30" AXIAL FLOW PUMP MODEL-30 x .1.0

SECTION 15130

PUMP AND DRIVE UNIT

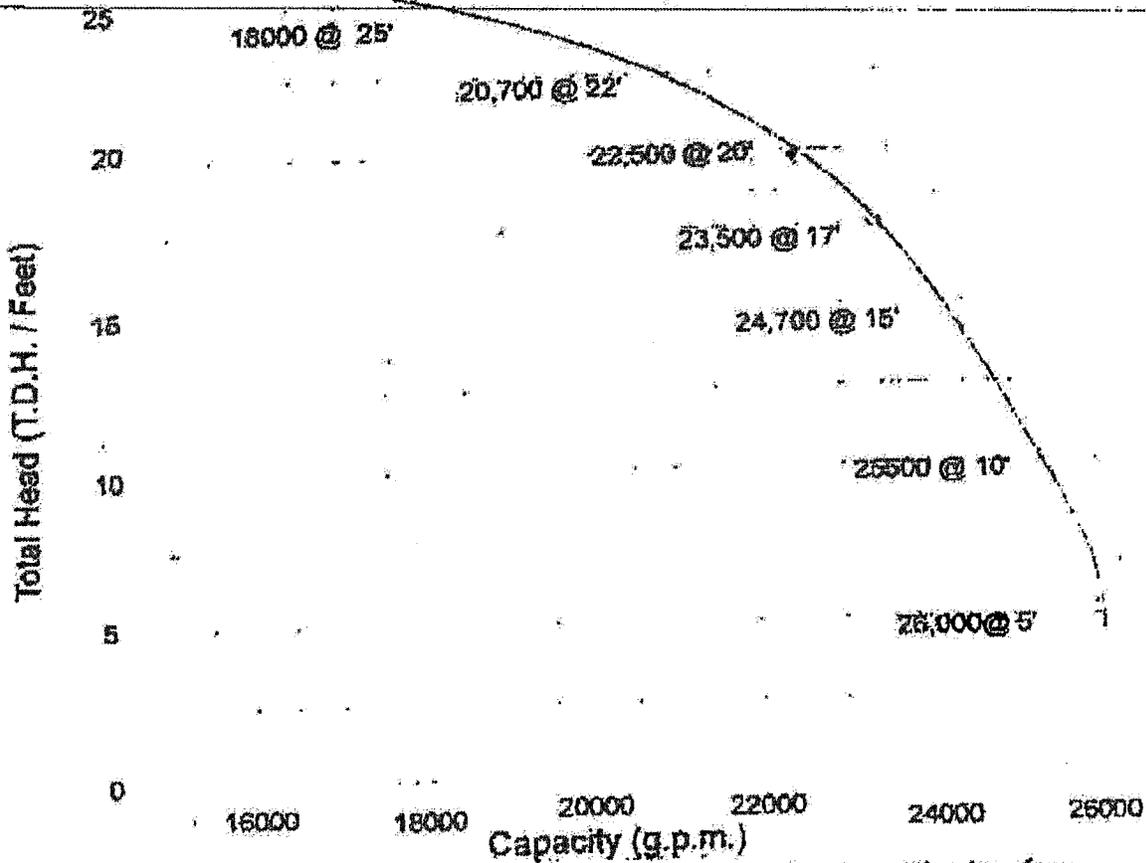
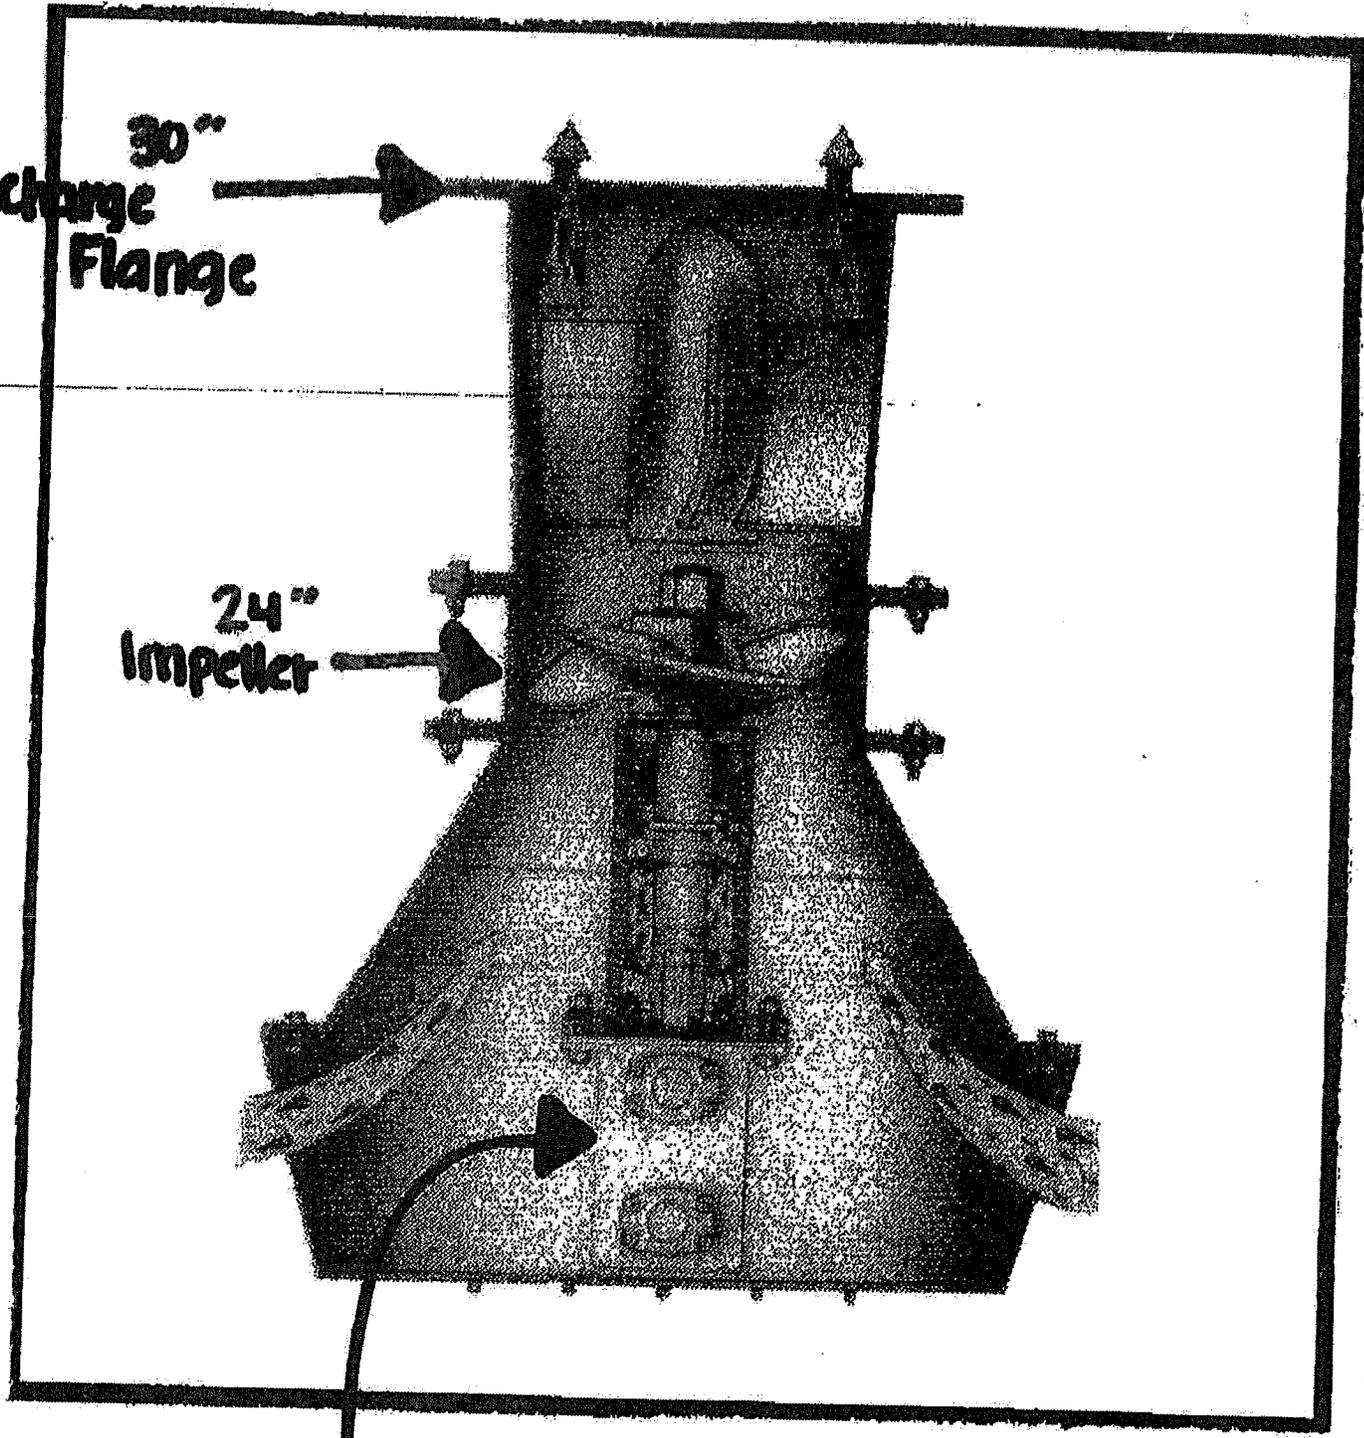
D+D
- has
Hyd Motor
ON Bottom PRO
ON TOP
